FINAL DRAFT MINUTES

June 16, 2016 Standards Committee Meeting

RE: Minutes from the June 16, 2016 Standards Committee Meeting

REVISION TO STANDARD SPECIFICATIONS AND STANDARD DRAWINGS
 805-SGSC-01 POLE ALIGNMENT (WITH MARKUPS, *SEE* SIGNATURE BOX)

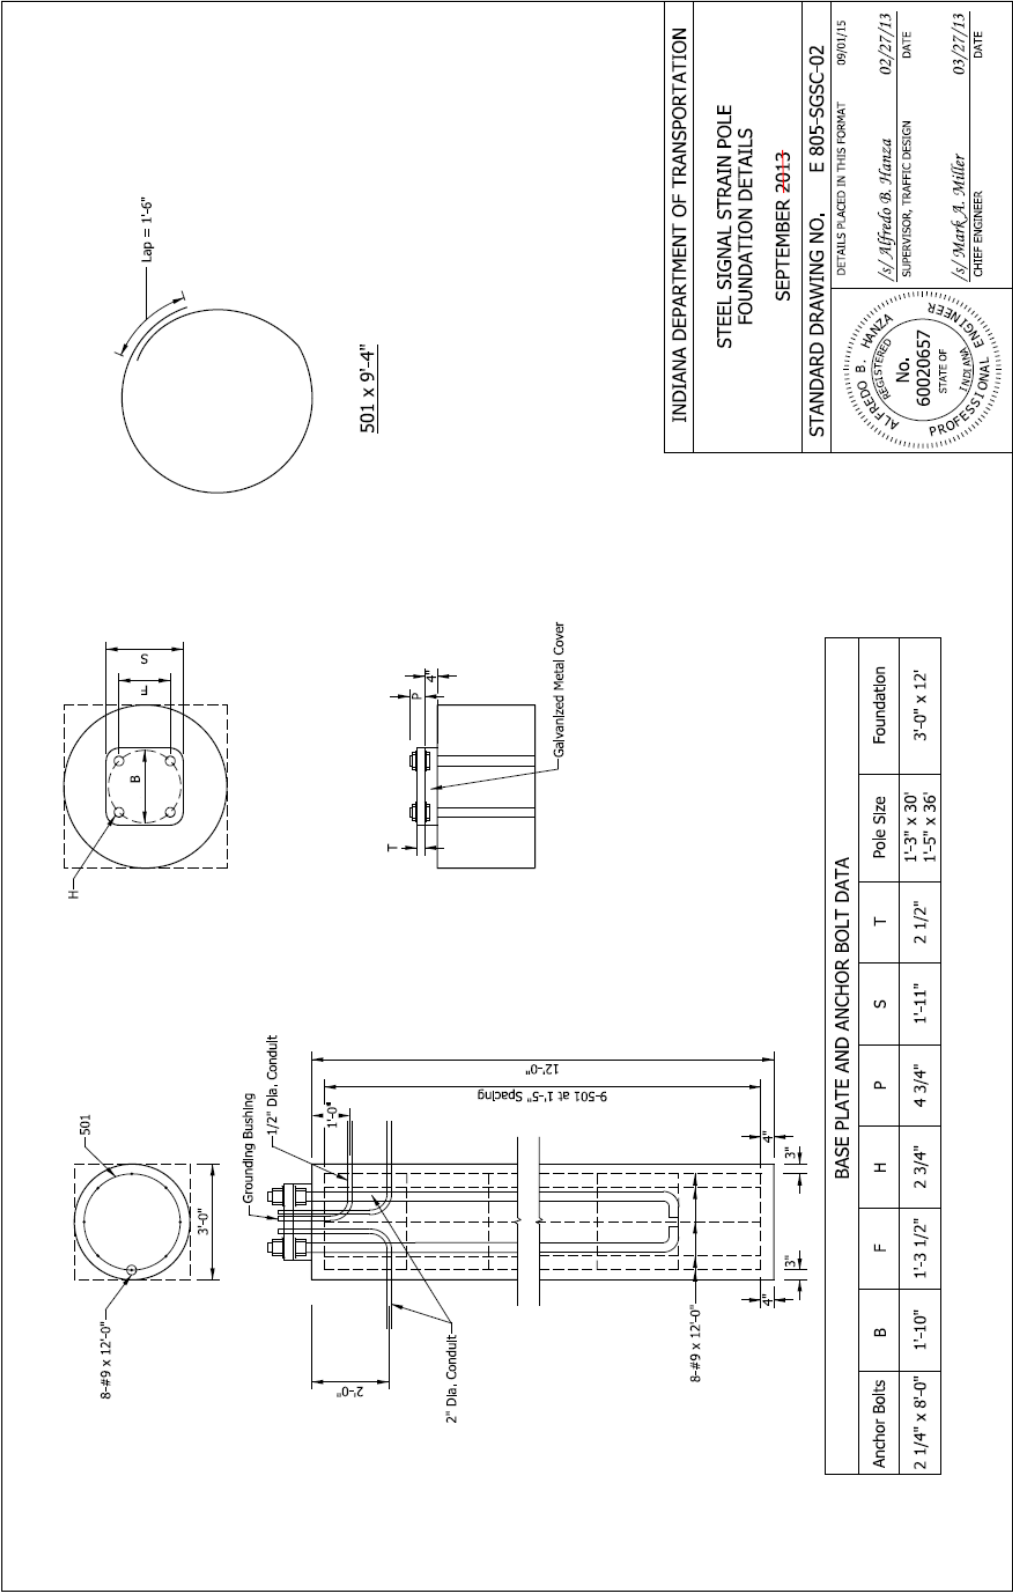
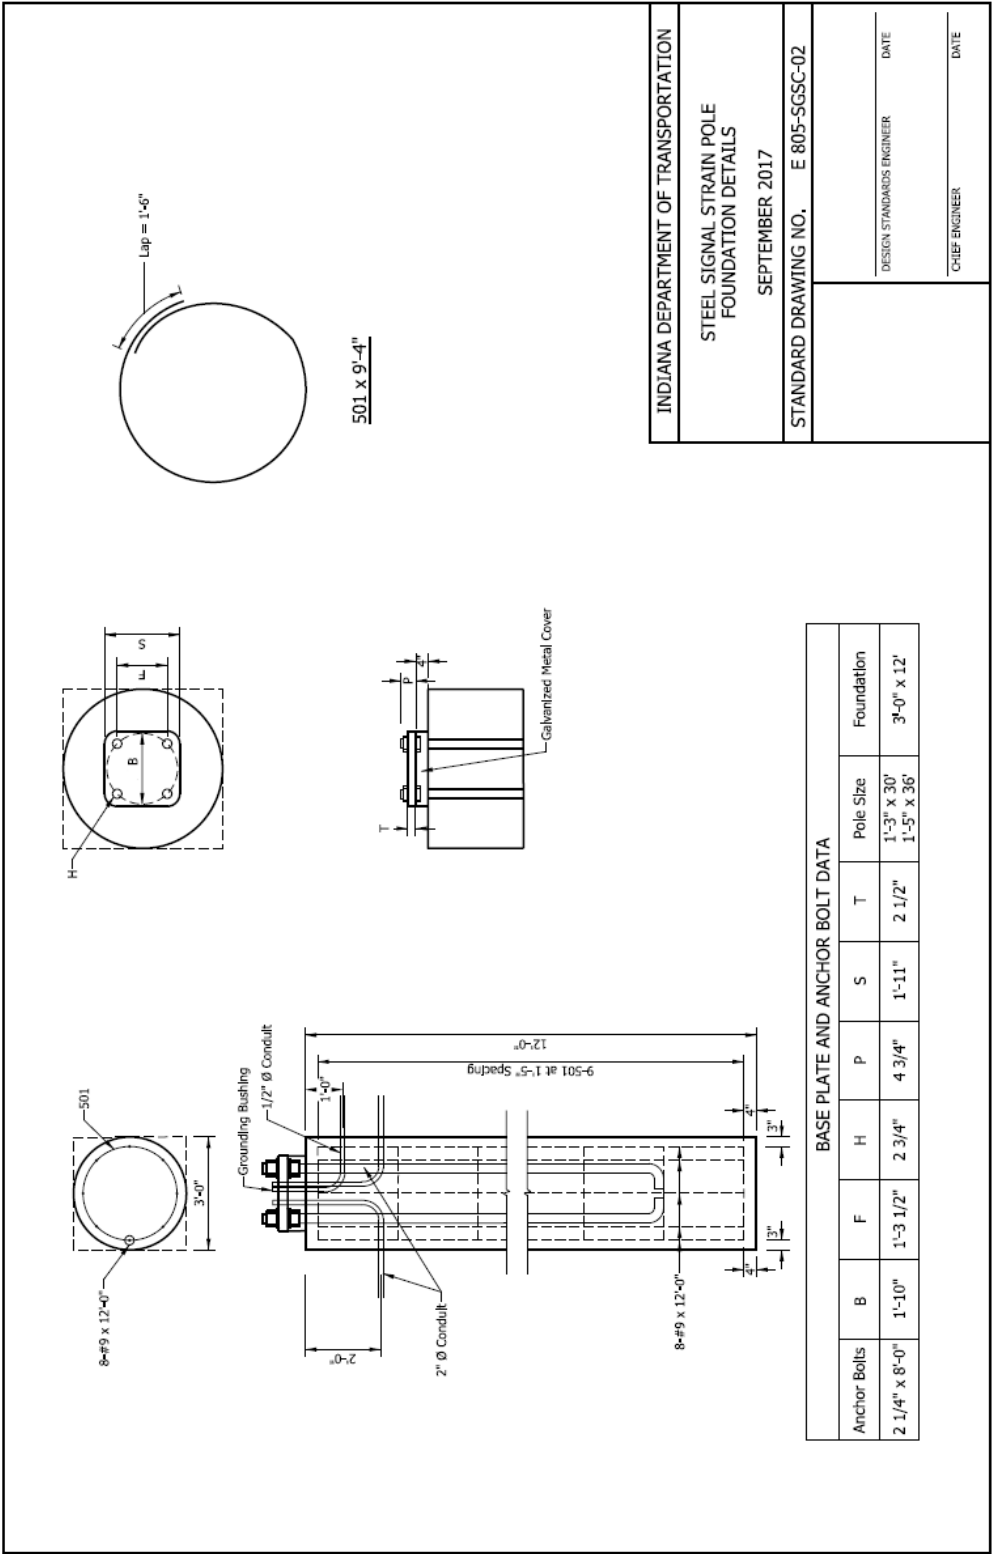
The tether bracket shall attach to a ~~1/8 in. to~~ 1/4 in. ~~messenger cable~~ *tether* and prevent the bottom of the head from moving side-to-side on the ~~cable~~ *tether*. Where backplates are installed on the signal heads, the tether bracket shall be of the proper length for the backplate so that the cable is mounted below the bottom of the backplate to avoid interference with head alignment and damage to the backplate. *Three bolts, nuts, and washers, shall be used to secure the tether bracket to a three-section or four-section signal head. A wire rope clamp in accordance with 922.10(e)4c, shall be used to secure the tether bracket to the tether and the tether bracket shall have predrilled 1/2 in. diameter holes. In lieu of the wire rope clamp and 1/2 in. diameter holes, a beveled tether plate that completely fills in the extruded portion of the tether bracket may be used to secure the tether bracket to the tether. The tether bracket shall not extend more than 2 in. below the tether.*

Tether and support cable shall be aircraft cable, for non-aircraft, and shall be ~~3/16~~ 1/4 in. nominal diameter, made of stainless steel wire, and consist of seven, ~~seven~~ 19-wire flexible steel strands. The ~~3/16~~ 1/4 in. cable shall have a minimum breaking strength of ~~3,700~~ 3,840 lbs. It shall be in accordance with Military Specifications MIL-W-83420D.
